American Transportation Corporation

RECALL NOTICE

AMERICAN TRANSPORTATION RECALL # 01303
NHTSA RECALL # 01V-269

Dear American Transportation Bus Customer:
Issue: Flip Seat Support Binding

Picture Showing Cushion Frame Support Bar Ready to Slip Off Seat Support Tab

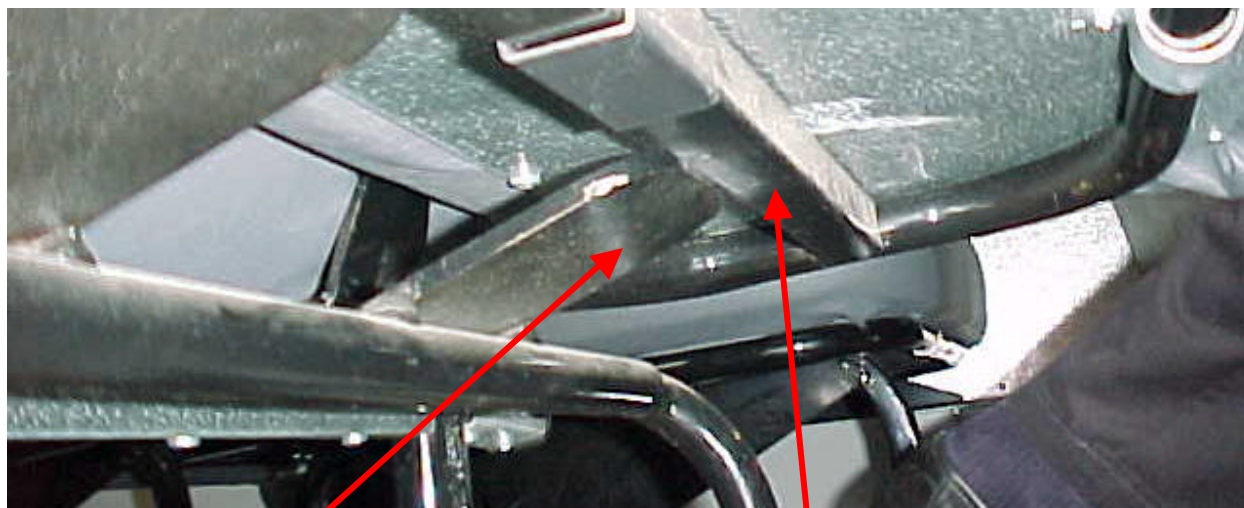
The cushion frame support bar slides off the seat support pad. When this occurs, the tabs can wedge against the support bar, which may retain the seat in the occupied position.
